COMMUNITY DEVELOPMENT DEPARTMENT
Engineering Division
1725 Reynolds Street, Suite 200, Brunswick, GA 31520
Phone: 912-554-7428 /

August 13, 2019

Subject: Oak Grove Island Cswy. – Culvert Maintenance and Improvement Project
Information to address items requested at the June 2019 committee meeting

Oak Grove Island Culverts with 42-inch HDPE Liners

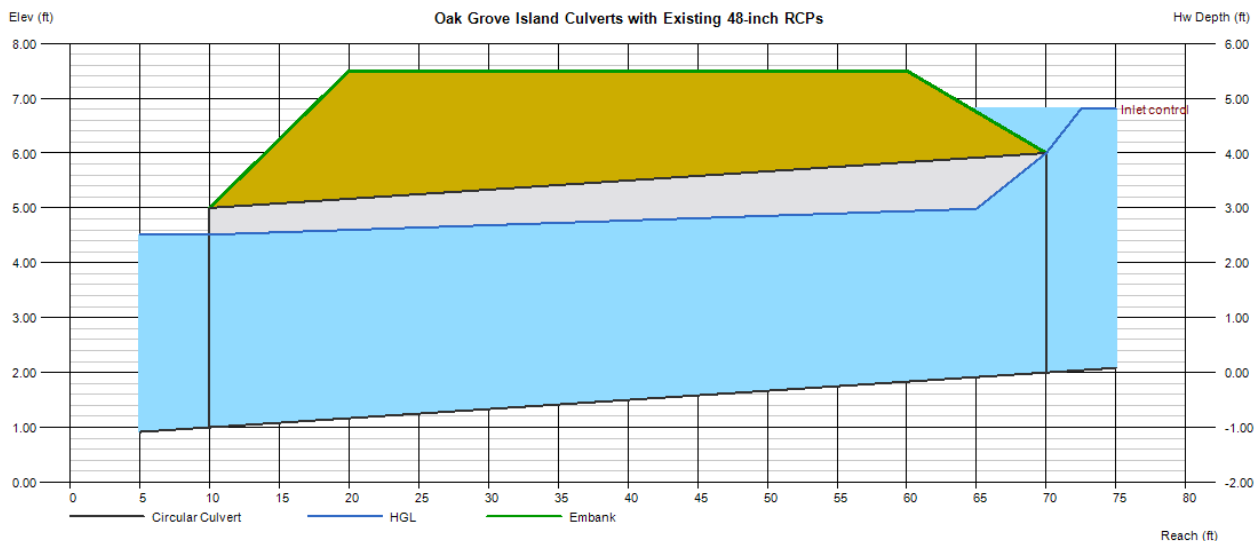
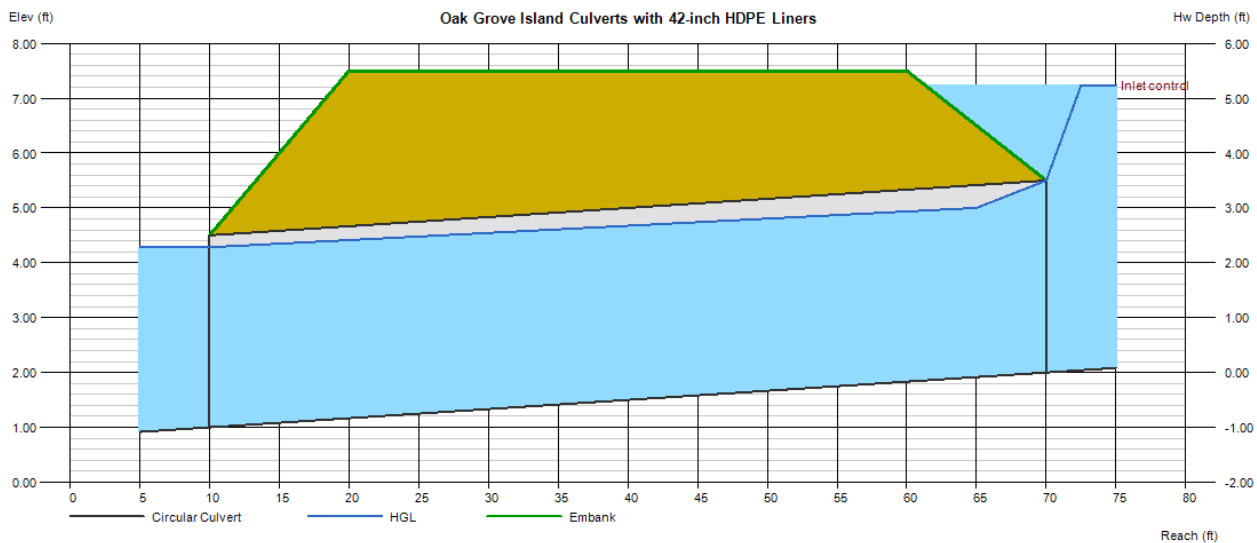
The calculations in Appendix 2 includes plans for the project and calculations of the expected water velocity at the pipe end now and when the pipes are lined. The calculations show an increase in water velocity at the end of the pipe of 25% (8.55 to 10.67 feet per second). This is representative of the one pipe that does not have a flapper type tide check valve, the increase is expected to be less at the pipe ends with the check valve since the valves effect of slowing the water velocity is more pronounced with higher velocities.

Figure 6-34.1 - Design of Outlet Protection From a Round Pipe Flowing Full, Minimum Tailwater Condition ($T_w < 0.5$ Diameter)

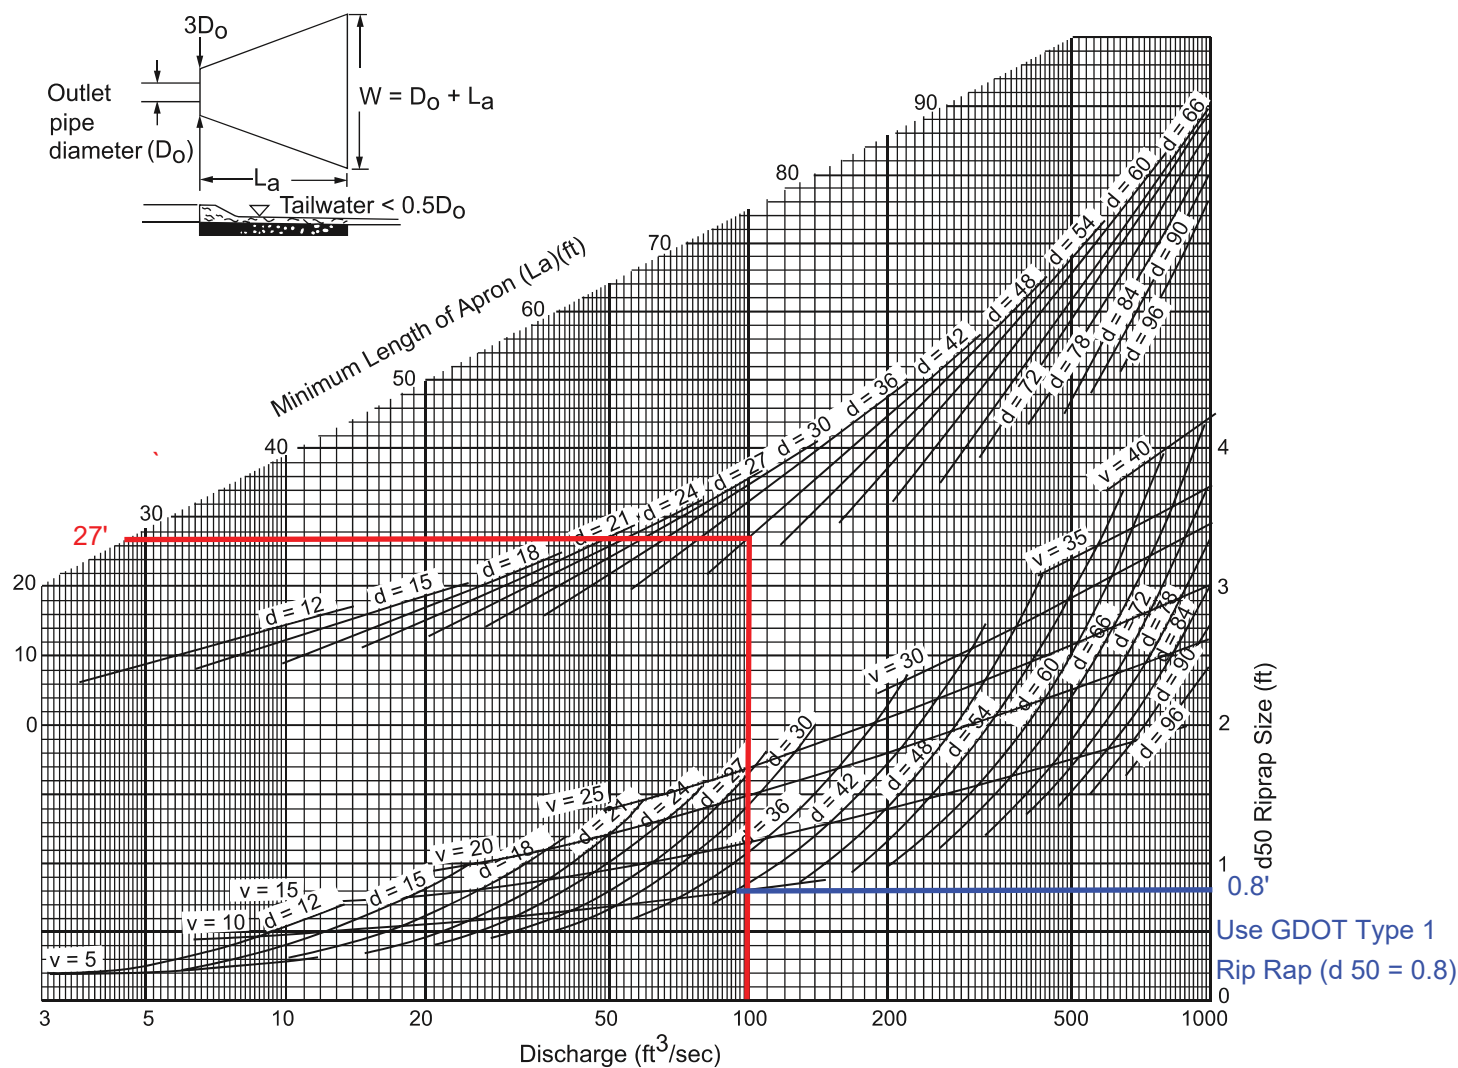
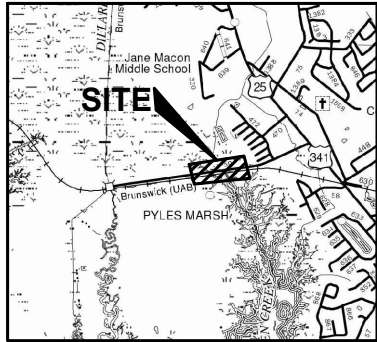
Erosion caused by Pipe end velocity increases will be mitigated by the installation of additional rock at the pipe ends to provide for scour control and velocity dissipation. The rock size and pad dimensions are taken from the design nomograph and incorporated in the plan (see nomograph and plans in Appendix 2)

AREA ADJACENT TO THE WESTERN CULVERT SET AT LOW TIDE AND LOW TIDE PLUS 2-INCHES

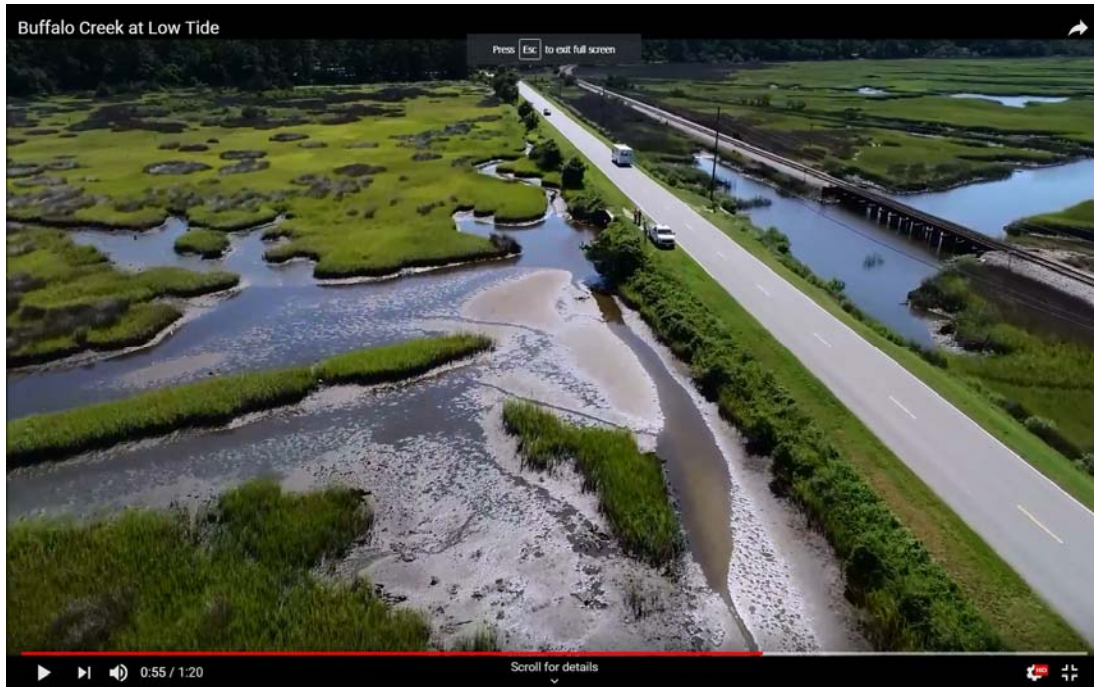
As described above, this project includes lining the existing pipes and thereby raising the invert of the pipes by approximately 3-inches. This alteration in the pipe invert will result in more water being held in the area upstream from the culverts. Appendix 3 includes aerial photos of the area of trapped water and the mud flat creek lines at low tide and at low tide plus 2-inches. A comparison of the wetted area indicates that the area that will be changed to permanently wetted is very small relative to the basin area. Further, this converted area will provide additional habitat for the fish and other animals that currently live in the waters held above the culverts. Non Marine animals in the area (i.e., wading birds, birds of prey,...) should benefit from the slightly increased habitat for the marine wildlife.
